Subject: Change Oder 005- Midway Branch Force Main Conflicts and other Scope Modifications

Change Order 005-Midway Branch Force Main Delays

Change Order No. 05
Corporate Dr Segments 4&5
Project No. G1124 &G1125

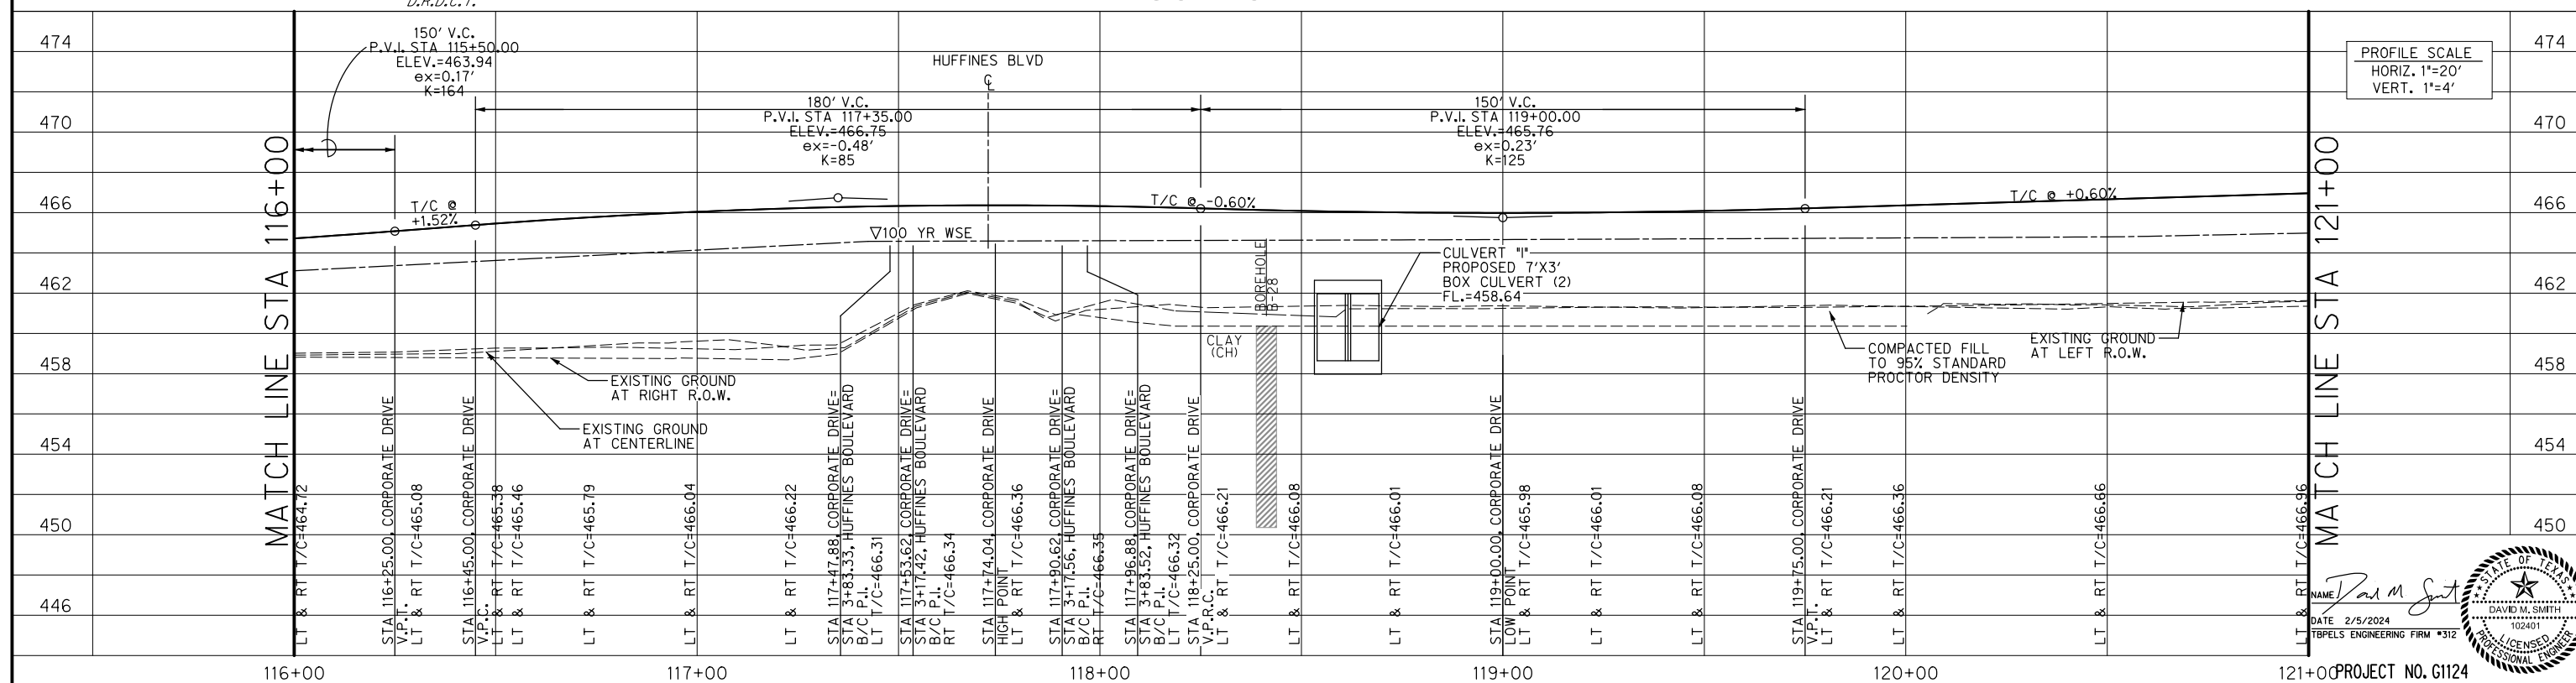
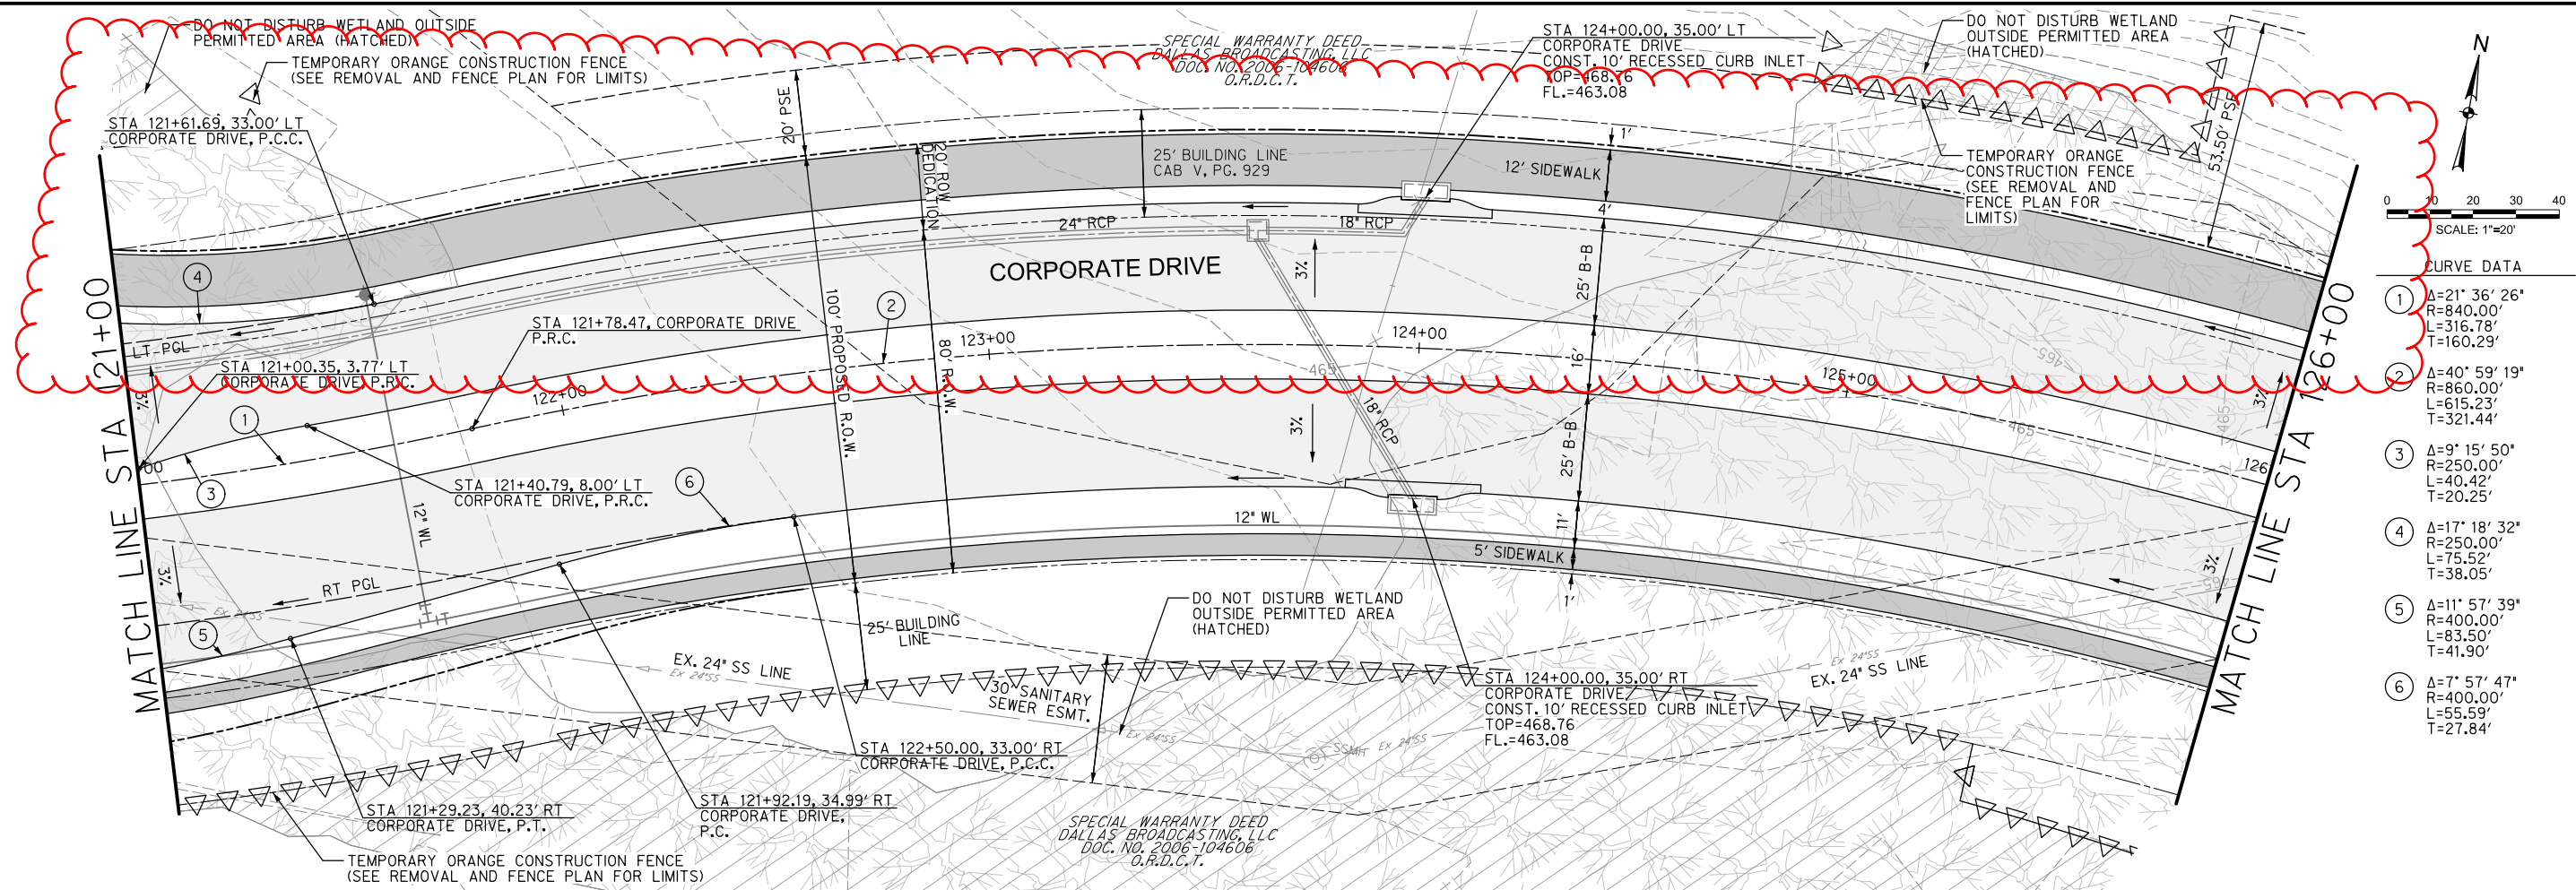
sidewalk delayed due to Midway Branch Force Main
